Formal Interpretations/ Interprétation formelle

This section lists questions that individuals have submitted about a particular standard. Each question has been reviewed and answered by the appropriate committee. If you would like to submit a question about a particular standard, please see the end notes in the preface of that standard.

Figure 1

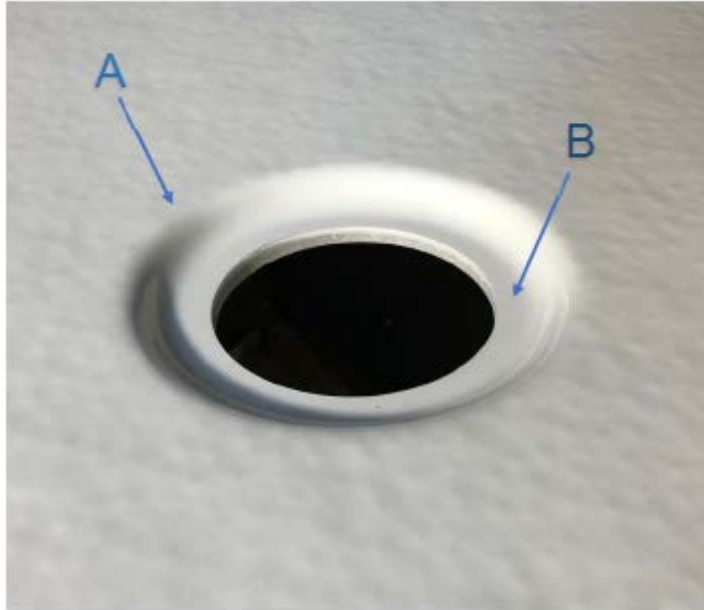
Question: As indicated in Figure 8, the “top of drain opening” is the horizontal plane across the floor of the shower receptor at the waste opening. In some case, the actual waste opening sits in a depression in the shower floor. Once a waste fitting is installed, the grate (top of the waste fitting) is level with the floor of the shower receptor. In the case where a waste fitting is not factory supplied with the shower base, is the threshold measured from (refer Figure 1):

Answer: Point “A”: the horizontal plane across the floor of the shower receptor above the actual waste opening.

Figure 1

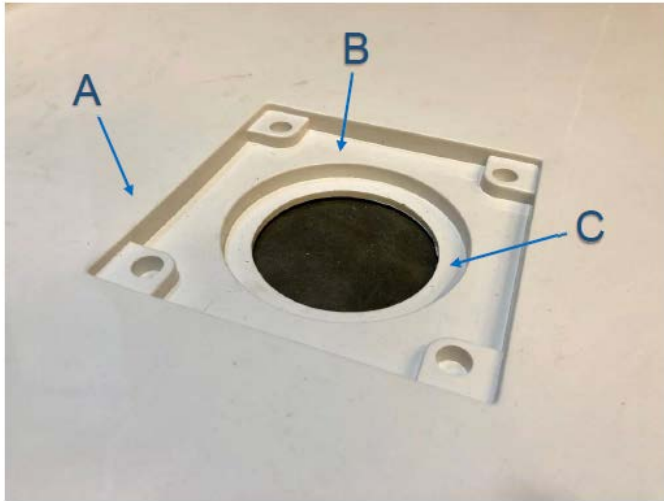
Question: As indicated in Figure 8, the “top of drain opening” is the horizontal plane across the floor of the shower receptor at the waste opening. In some cases, the actual waste opening sits in a depression in the shower floor. Additionally, that depression sits in a secondary depression which houses a decorative tile. Once a waste fitting is installed, the grate (top of the waste fitting) still sits well below the floor of the shower receptor. For reference, Figure 2 depicts the unit with decorative tile in place. In the case where a waste fitting is not factory supplied with the shower base, is the threshold measured from (Refer to Figure 1):

Answer: Point “A”: the horizontal plane across the floor of the shower receptor above the actual waste opening

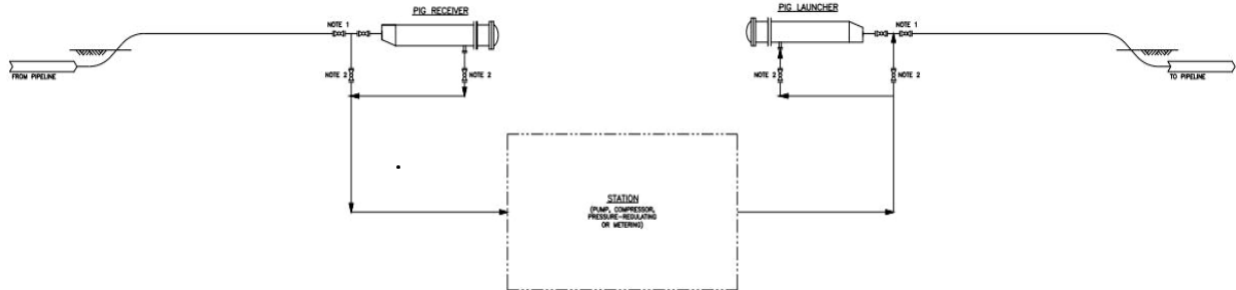
Question 6: For traps located at a station (compressor, metering, pump or pressure regulating), could the mainline valves on the pipeline side of the pig traps labeled Note 1 be considered station isolation valves in the sketch below?

Question 7: For traps located at a station (compressor, metering, pump or pressure regulating), could the valves adjacent to the pig trap (side valve and kicker valve) labeled Note 2 be considered station isolation valves in the sketch below providing all four valves are closed?.

Answer 6: Yes

Answer 7: Yes

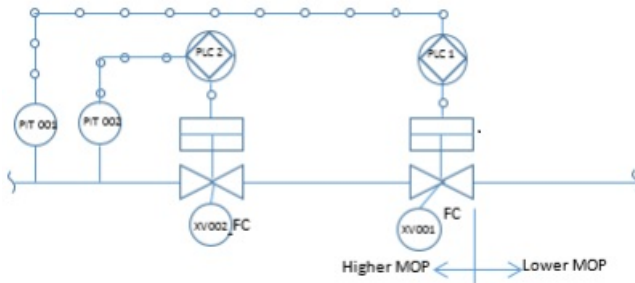
Question 1: The pressure control and overpressure protection for a pipeline as required by Clause 4.18.2 is accomplished by a local control system as described in Annex M.5 and inspected, assessed and tested in accordance with Clause 10.9.5.2. The local control system incorporates programmable logic controllers (PLCs). Does Clause 4.18.2 a) require two completely separate PLCs to be provided as shown below?

Answer 1: No

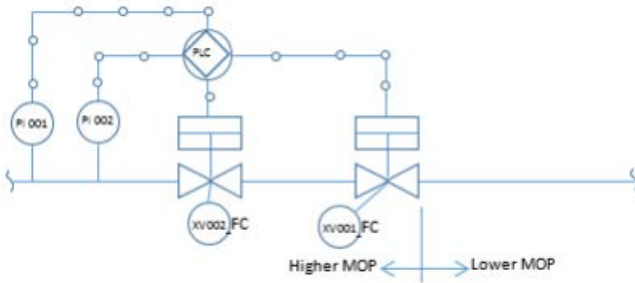
Question 2: If the answer to Question 1 is “no”, would two separate and independent control loops within a single PLC as shown below, satisfy the requirements of Clause 4.18.2; provided that failure of one system cannot lead to failure of the other system?

Answer 2: Yes

Figure 1

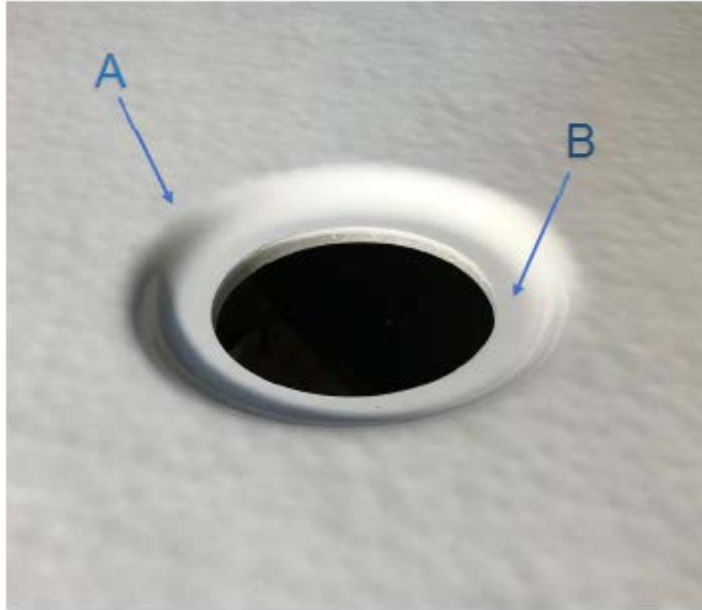
Question: As indicated in Figure 8, the “top of drain opening” is the horizontal plane across the floor of the shower receptor at the waste opening.

In some case, the actual waste opening sits in a depression in the shower floor. Once a waste fitting is installed, the grate (top of the waste fitting) is level with the floor of the shower receptor.

In the case where a waste fitting is not factory supplied with the shower base, is the threshold measured from (refer Figure 1):

Answer: Point “A”: the horizontal plane across the floor of the shower receptor above the actual waste opening.
